# PLATEAU MINING COMPANY

RE: Special Stipulation No. 6, Refuse Pile Research Plots,  
December 9, 1984 Division Letter. ACT/007/006

REFUSE PILE RESEARCH STUDY

#### RESPONSE TO STIPULATION NO. 6

FIGURE 1 - EXAMPLE OF THE DIVISION OF TREATMENTS INTO SUB-SAMPLING PLOTS.

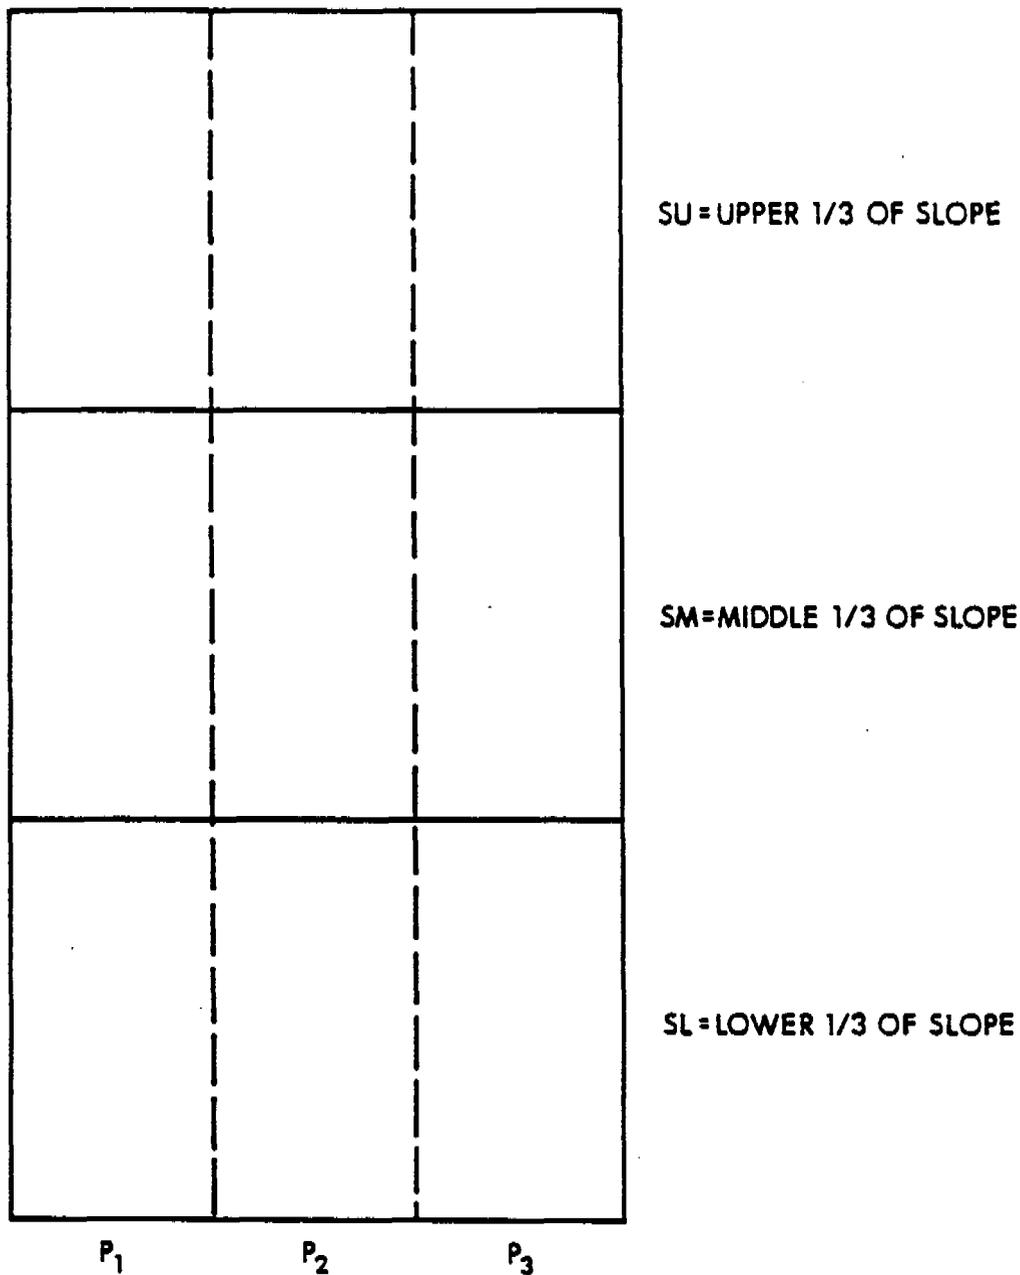
b. Why were replications not implemented in the study, or shown on Map #1?

In reference to Map No. 1, there are three replications to the subsoil treatment and 3 replications of the topsoil treatment. For each soil treatment there are two depth replications. The effect of fertilizer treatment is replicated six times. During the 1984 and 1985 data collection, each treatment will be further separated into three replications. See Figure 1 and Figure 2 in the Methods section for a diagram of a plot and plot identification labels.

The Refuse Pile Research Study Plots are comprised of two main treatments, soil material and depth of soil material. Soil materials are composed of topsoil, subsoil, layered topsoil/subsoil, and coal waste material. Each source of soil material has been applied at depths of ten inches and twenty inches with the exception of the layered topsoil/subsoil which was applied at a depth of twenty inches only and the coal waste material which is the refuse material over which the other soil materials has been placed. Each main soil treatment plot is divided into two fertilizer sub-treatments and three slope effect plots. Fertilizer, 16-16-8, was applied at the rates of 100 lbs/acre and 200 lbs/acre. Fertilizer treatment plots have been partitioned into slope factors, upper, middle and lower slope with three sub-plots within each slope factor plot. A diagram of this is presented in Figure 1, Example of the Division of Treatments Into Sub-Sampling Plots.
